DEVELOPMENT REVIEW BOARD
SUPPLEMENTAL SUBMITTAL

PROJECT NO. PR-2020-004820

Re: Hotel Circle Ramada Apartment Conversion DRB Comment Responses (PR-2020-004820)

Re: Sidewalk Width Waiver for Apartment Conversion at 25 Hotel Circle NE

Figure 1: Site Location.

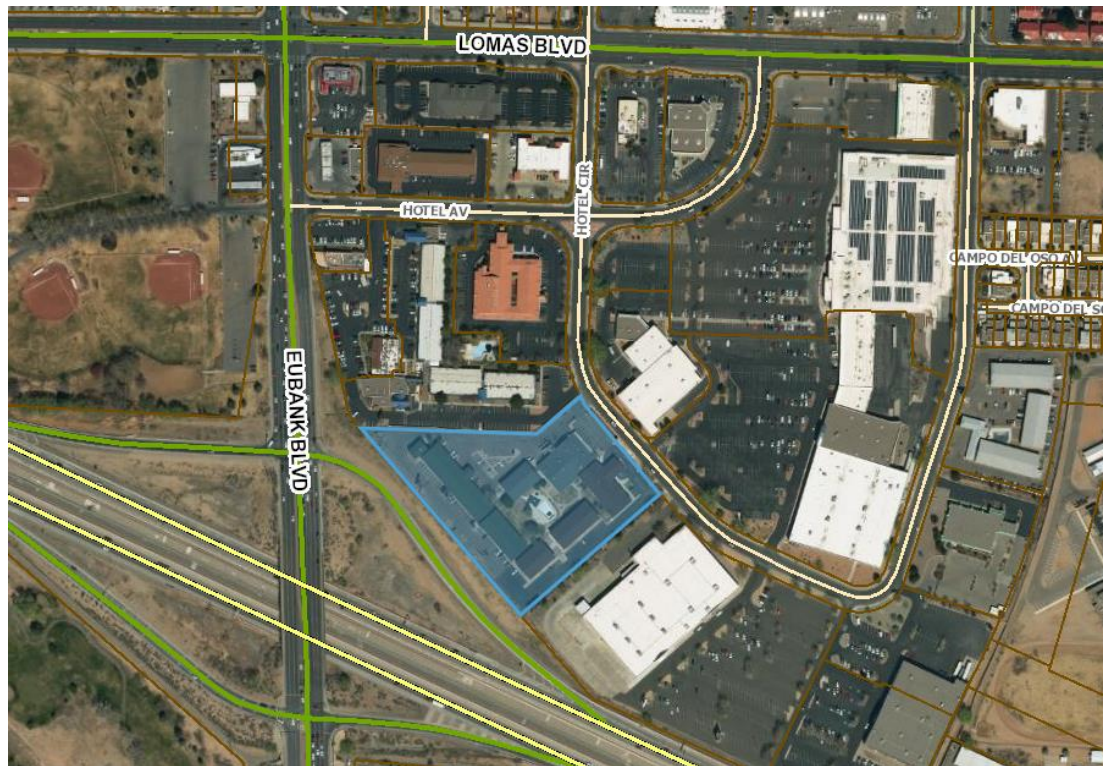
1. Waiver of 1-foot to the required 5-foot sidewalk width to allow the continued use of the existing 4-foot-wide sidewalk along Hotel Circle NE.

A1 ARCHITECTURAL SITE PLAN
1" = 40'-0"

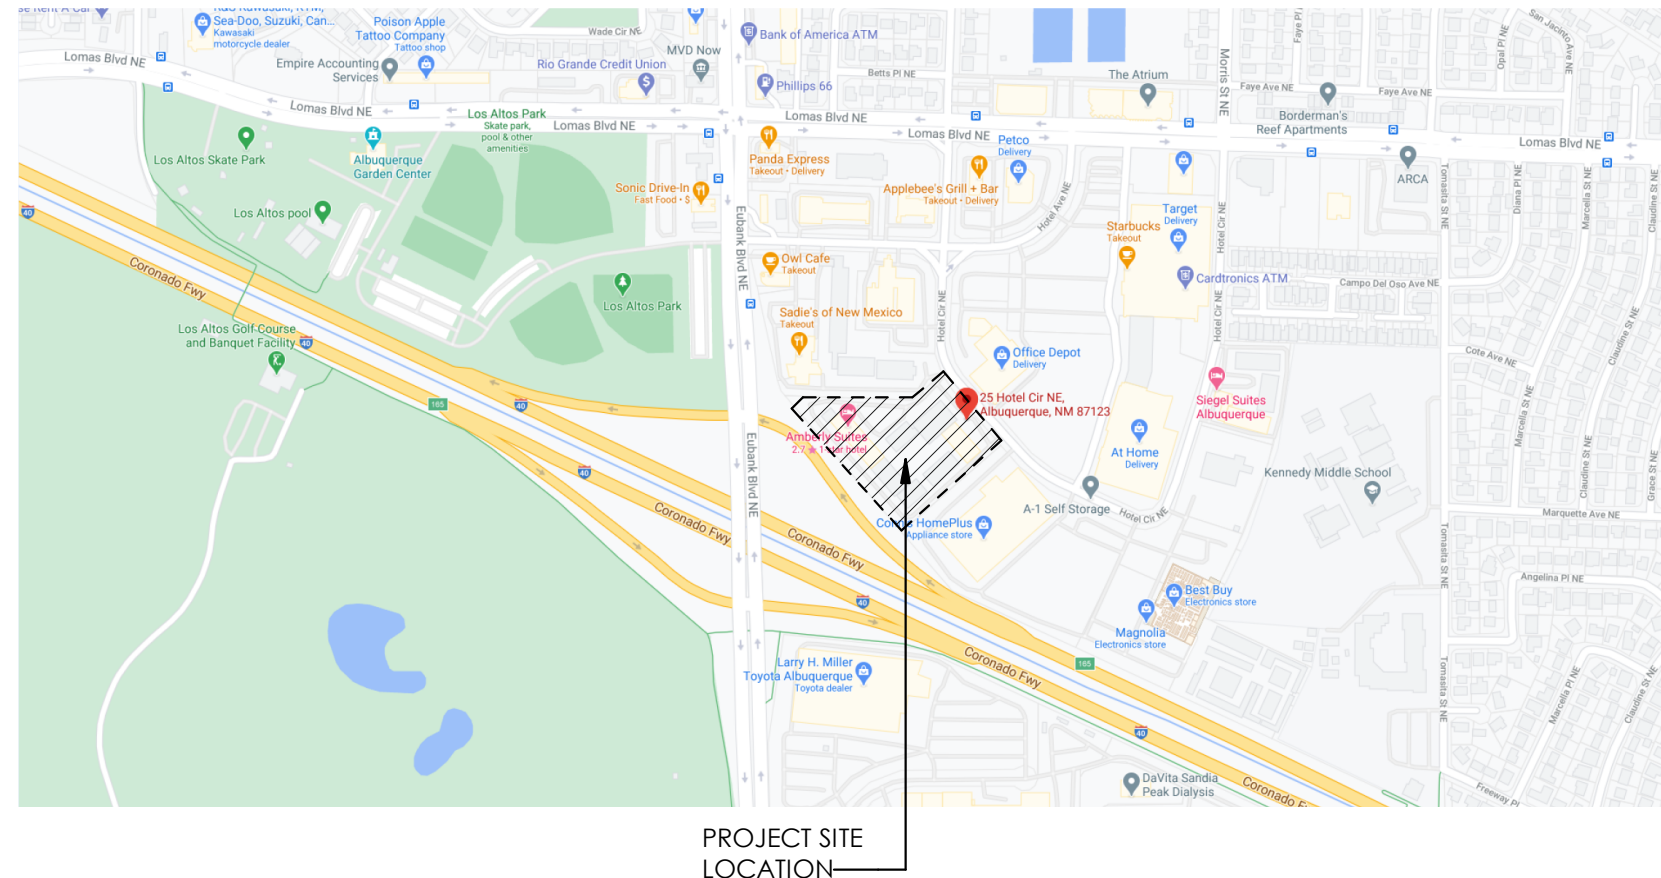
3. Clarify what will happen with the gated entrance. There are conflicting notes between the site plan and the comment responses.
 - a. ***The existing gate at the southern entrance that is located at the back of sidewalk will***

5. Where is keyed note 37?
 - a. **This Keynote has been updated and is now #38. These fence/gate locations are on either side of the building providing secured parking on the sides and rear of the site.**

6. How do all of the handicapped parking spaces have access to the building? Identify all existing and new curb ramps and 6-foot pedestrian paths from the handicapped ramps to the doorways. There appear to be accessibility issues for the handicapped spaces.

9. For the new parking spaces, mark these as "Compact" if they fall below the standard dimensions.
 - a. **Keynote #39 and the Legend clarify that these new spaces compact and the associated detail identifies the required pavement marking.**

be removed as part of this development (see Keynote #36). The two other gates on the north and south sides of the building providing entry to the rear portion of the parking lot are proposed to remain and be retrofitted for automated access with a Knox box provided for emergency access purposes (see Keynote #38).

- a. **New Keynote #43 identifies the locations of existing curb ramps at the existing accessible parking locations that will remain. 6-foot minimum pathways connect to the nearest building entrances from these spaces, as required.**

B1 SITE - TYP. FLARED ADA CURB CUT
1/4" = 1'-0"

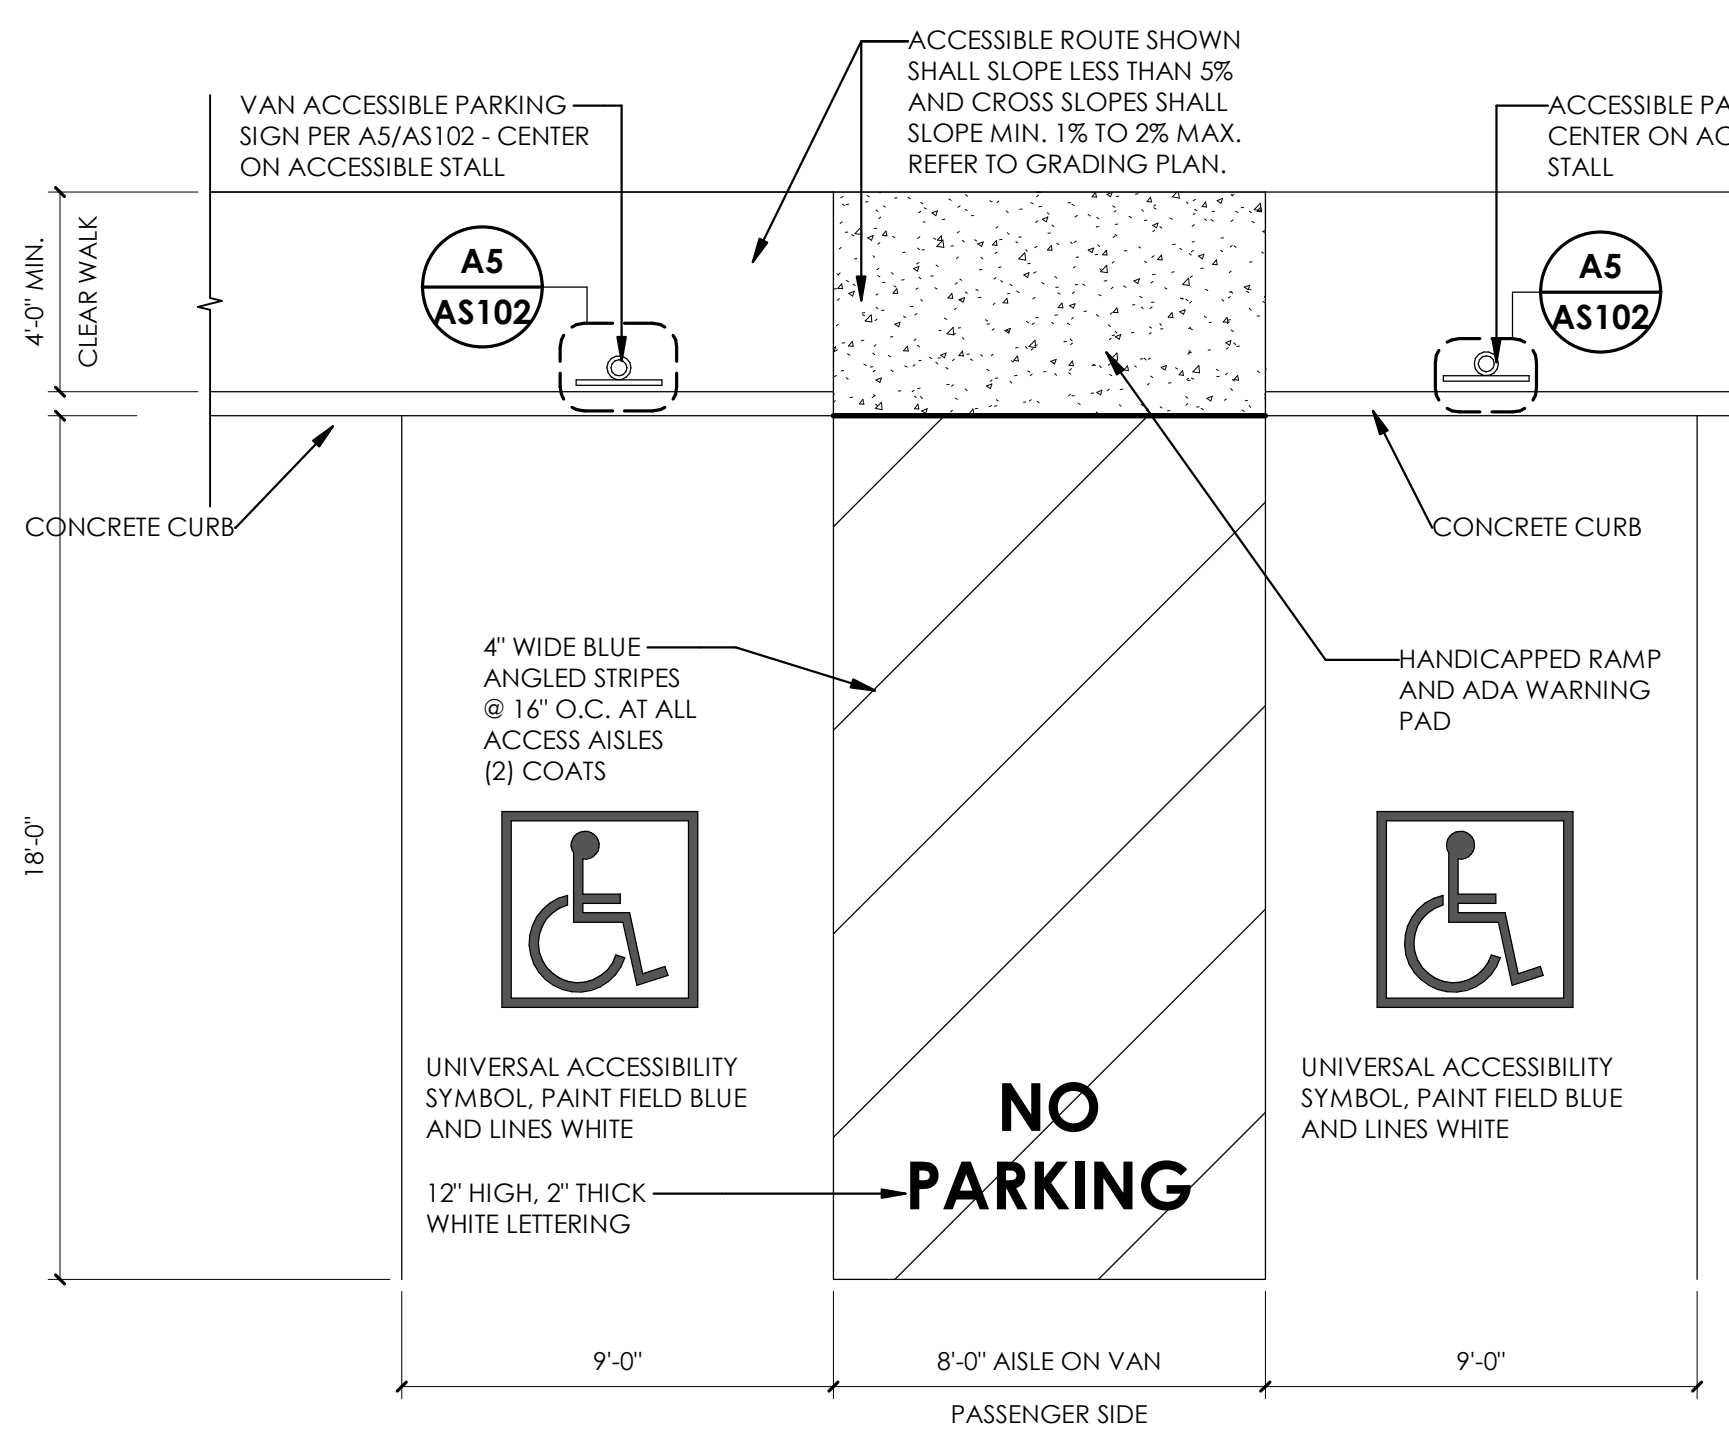
7. On the detail for the handicapped ramp that is perpendicular to the parking lot, show a minimum 4-foot pathway at the top of the ramp for turning a wheelchair.

- a. **This detail has been updated.**
8. Dimension all van accessible aisles and other handicapped aisles.
 - a. **Additional dimensioning has been added.**

ENLARGED SITE PLAN DETAIL @ EXISTING DRIVEWAY

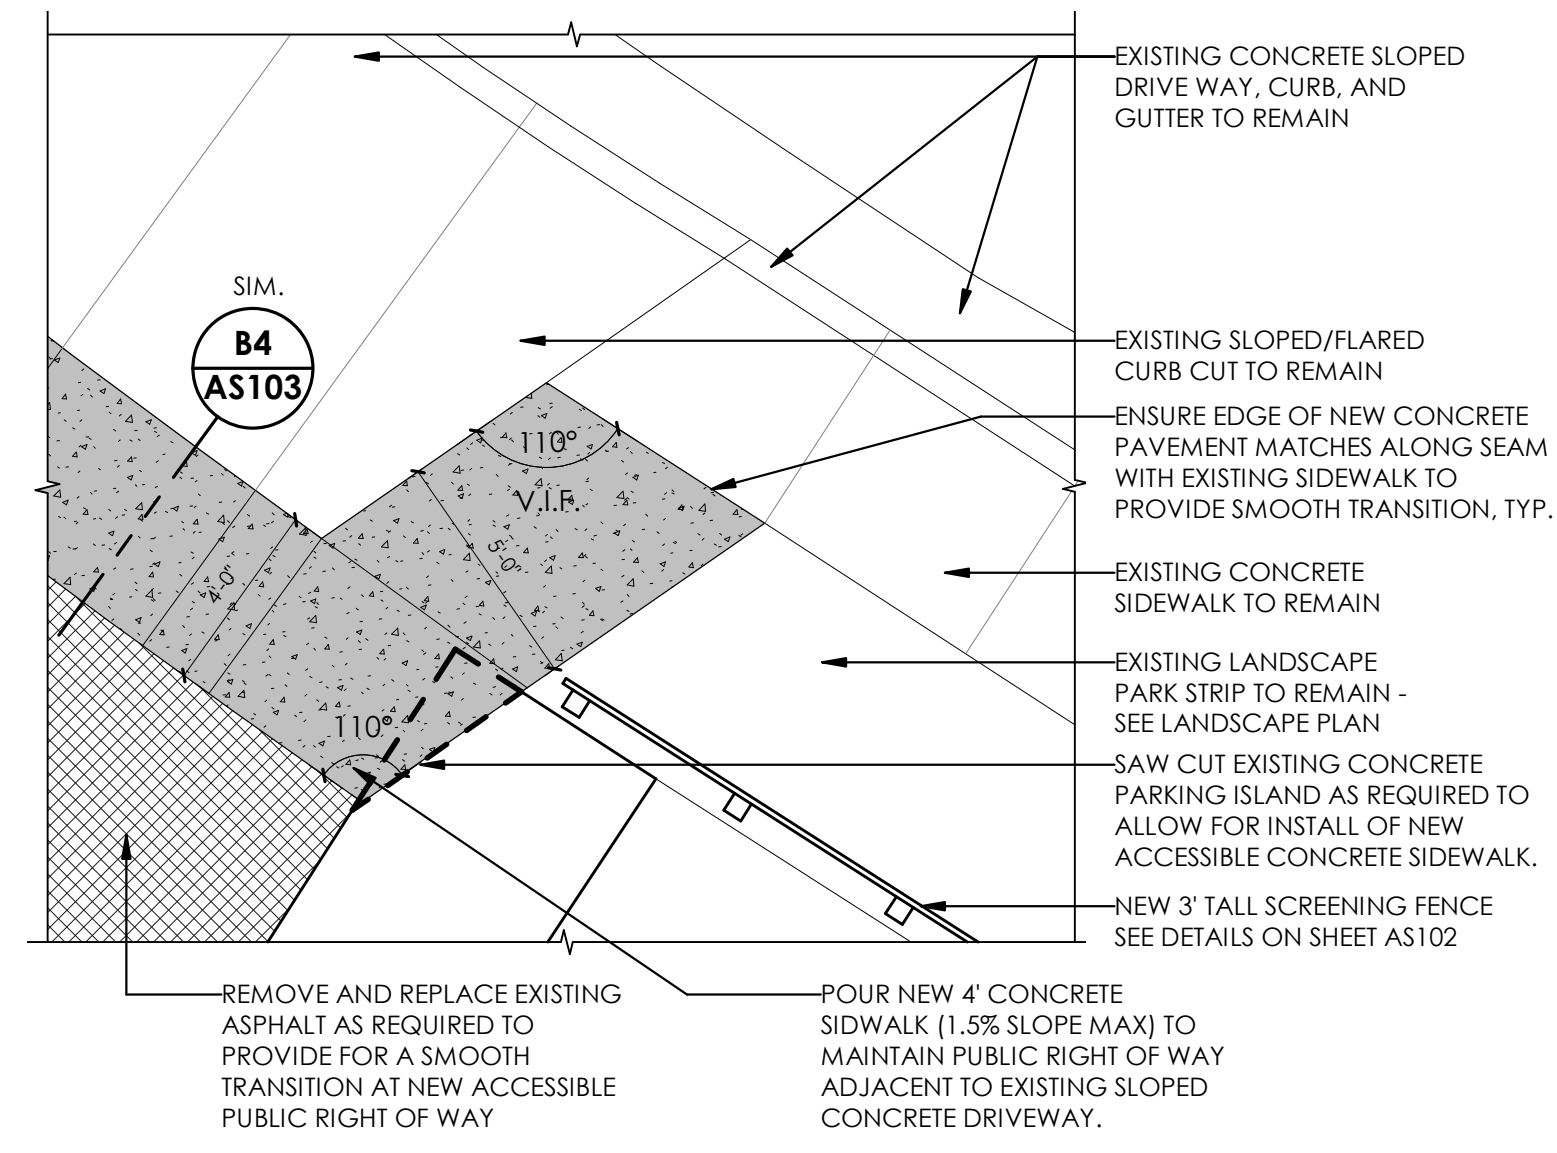
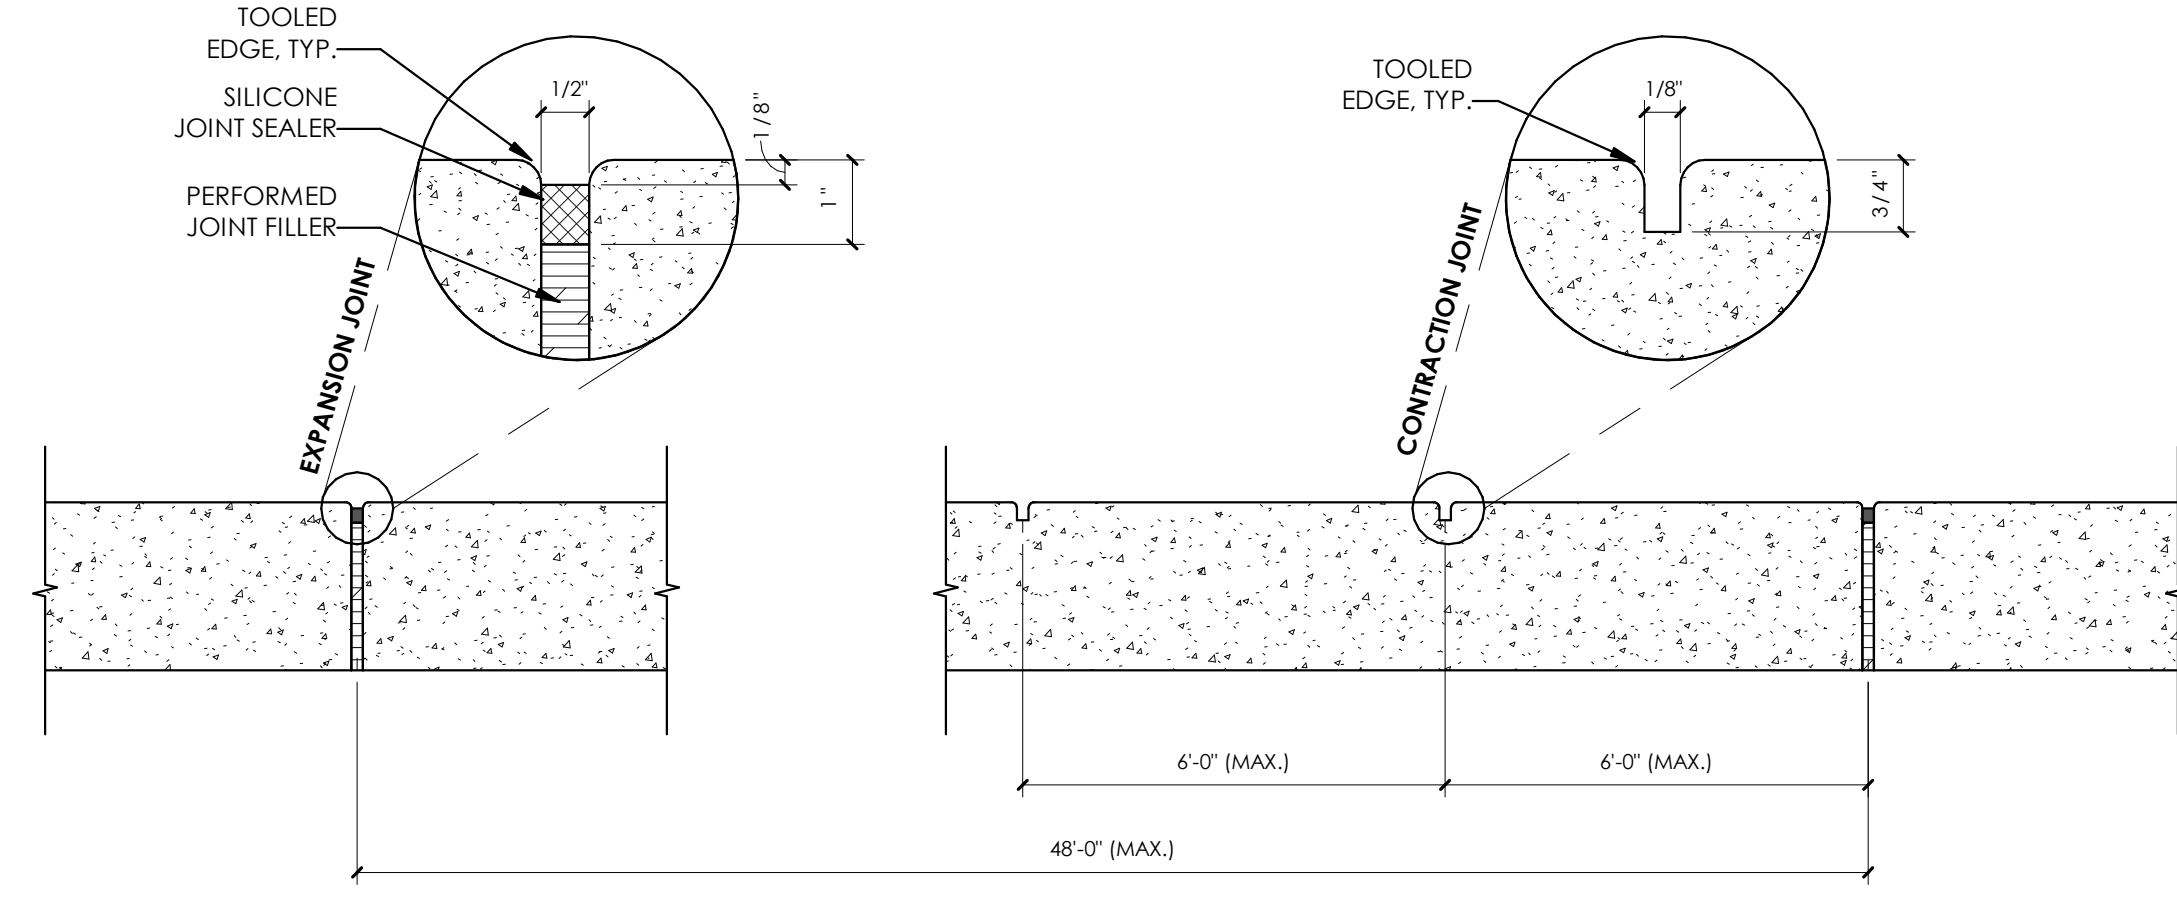
4. The driveways shall have a 4-foot ADA pathway. Provide details to show connectivity.
 - a. **The driveways have been updated to show a 4-foot pathway. A new detail showing this condition has been added on Sheet AS103.**
